BEFORE THE BOARD OF COUNTY COMMISSIONERS  
IN AND FOR THE COUNTY OF SKAGIT, WASHINGTON

**In the Matter of the Appeal of Special  
Use Permit, PL16-0556, for the  
expansion of a gravel mine.**

**APPEAL NO. PL23-0363  
OPENING BRIEF OF  
APPELLANT EVERGREEN  
ISLANDS**

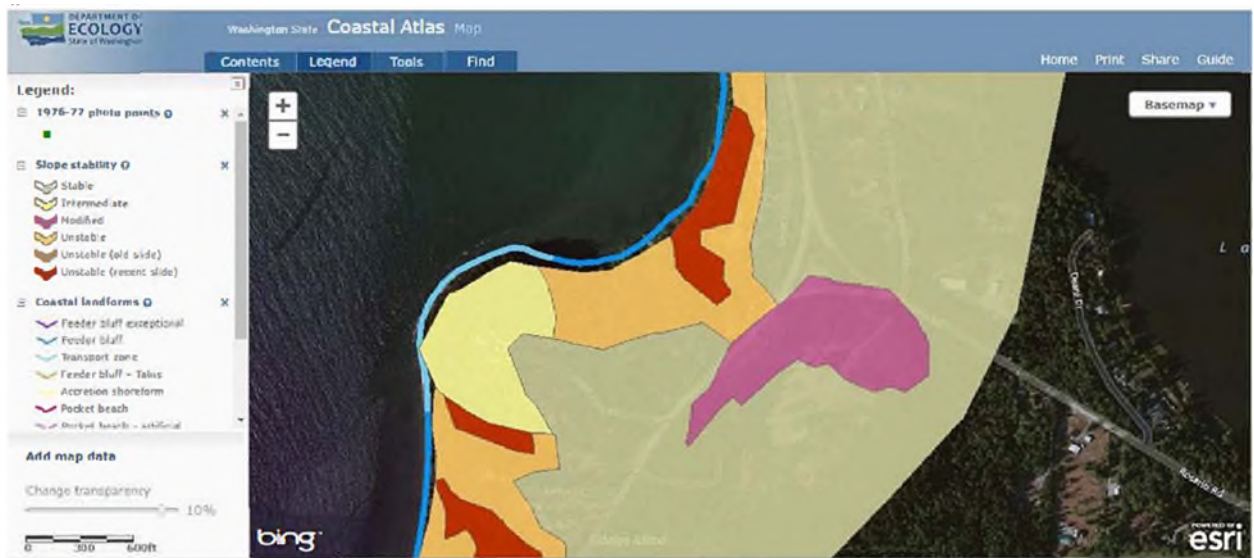
14  
15 Figures from the licensed geological report that Mr. McShane submitted into the record  
16 show that the Permit re-approves a substantial extraction operation adjacent to a landslide  
17 area.<sup>34</sup> As can be seen from Figure 1, copied below, the Washington Department of Ecology’s  
18 Coastal Atlas labels the mine with a purple overlay to show it as “modified” land and shows an  
19 “unstable” slope in orange abutting that modified area.<sup>35</sup> Within the area shown as unstable  
20 slope, the Coastal Atlas maps in red an area that has suffered recent slides, just over two  
21 hundred feet from the purple zone showing the mine.<sup>36</sup>

Figure 1. Washington State Department of Ecology Coastal Atlas slope stability map. Note that the slope immediately adjacent to the gravel pit (modified land in purple) is mapped as Unstable and within that unstable area is an area mapped as Unstable (recent slide). This map alone indicates that a mine site is adjacent to a landslide hazard area per the Skagit County critical areas regulations and the hazard should be evaluated.

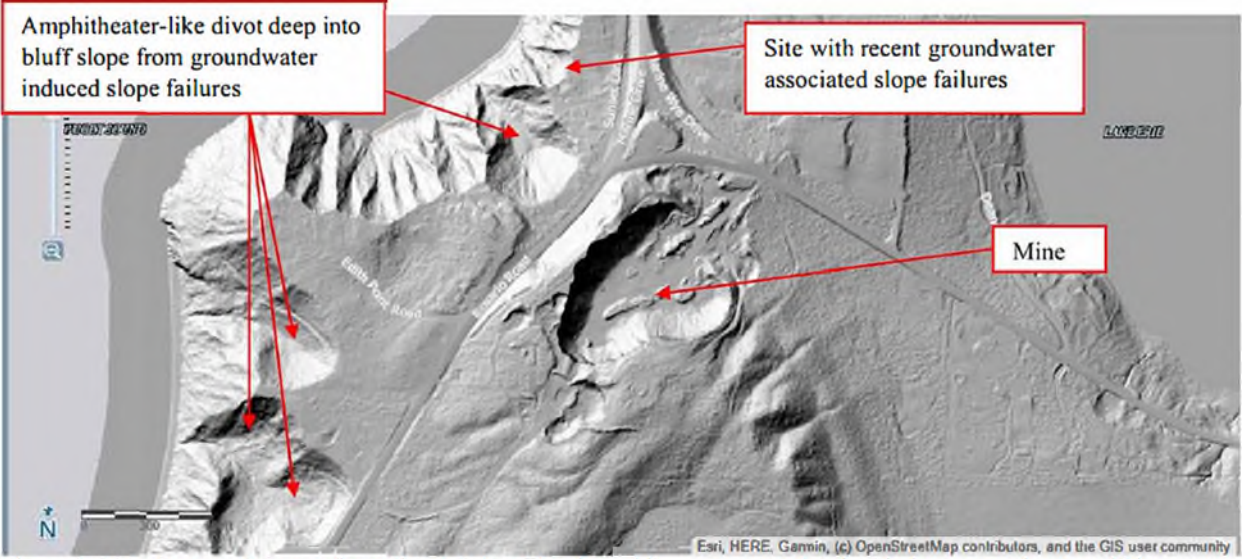
The map in Figure 2 below provides a clearer image of the topographic features at and adjacent to the site. As shown in the figure, the edge of the current mine is just 275 feet, less than the length of a football field, from the edge of one of the recent slope failures to the northwest.

Figure 2. Lidar bare earth image from Skagit iMap. The slope failures are associated with deep groundwater within a dense sand formation perched on an impermeable silt/clay formation. These deep divots are all associated with groundwater. When groundwater levels rise the increase pore pressures in the sand formation cause the bluff slopes to collapse. Controlling water inputs to groundwater is a critical factor for bluff stability.

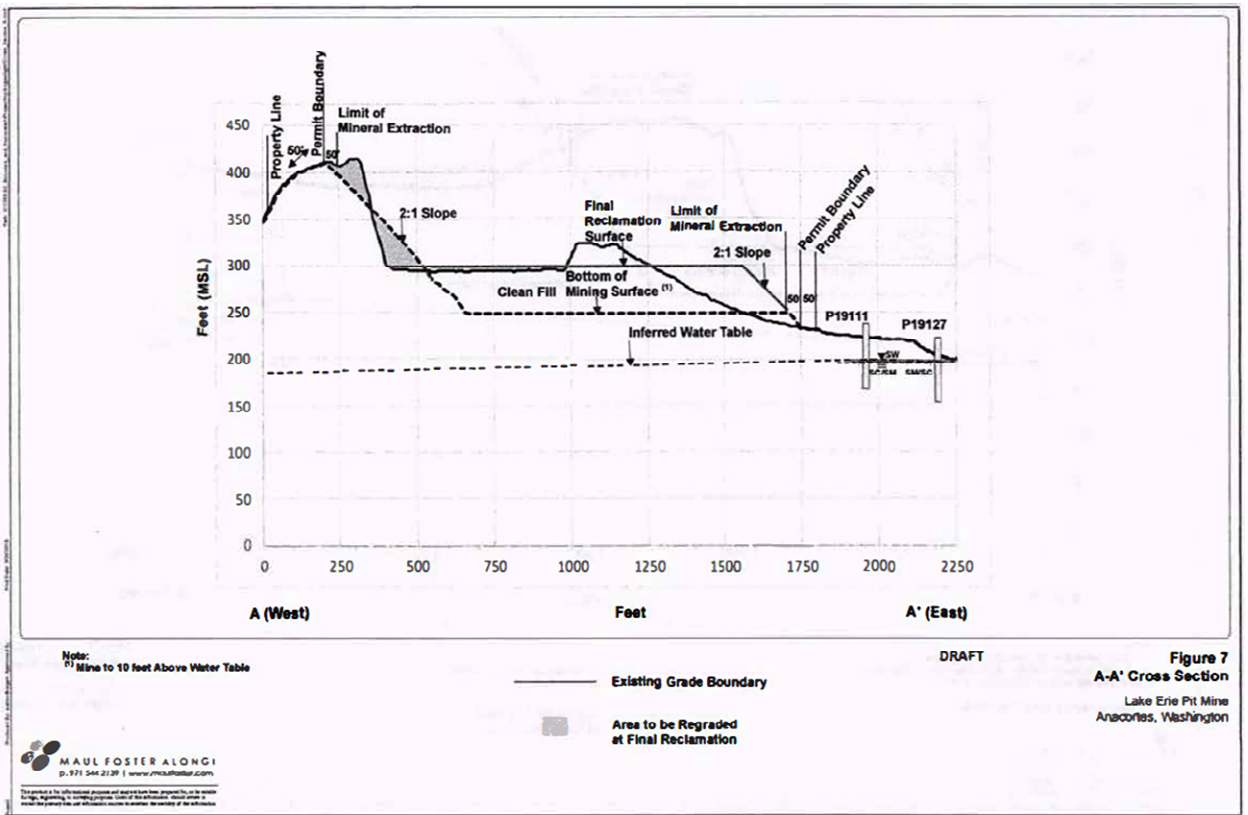
Notwithstanding these indications of landsliding, the applicant has not investigated groundwater levels northwest of the mine site. Mr. McShane explained in his October 12, 2020 memorandum that the applicant had not provided “elevation control” between the proposed mine expansion and the springs in the coastal bluffs to the northwest, as shown in this figure from the applicant’s consultant that omits well elevations there:

1  
 2  
 3  
 4  
 5  
 6  
 7  
 8  
 9  
 10  
 11 The Application materials still do not evaluate impacts to the geologically unstable  
 12 slopes abutting the mine based on an unproven assumption from earlier incomplete consultant  
 13 reviews that groundwater at the site flows to the northeast. The Wood study concludes that  
 14 “[t]he studies concluded that the proposed site development will not impact the groundwater  
 15 table or the stability of the coastal bluffs because groundwater flows from the site towards the  
 16 northeast, away from the bluffs...”<sup>39</sup> As noted in our brief 2 1/2 years ago, the hydrogeological  
 17 report asserts that groundwater flow beneath the proposed mine expansion should have no effect  
 18 on nearby slope stability based on an erroneous assumption that “the Mine will not be  
 19 generating any additional water and that all stormwater will be contained within the Mine
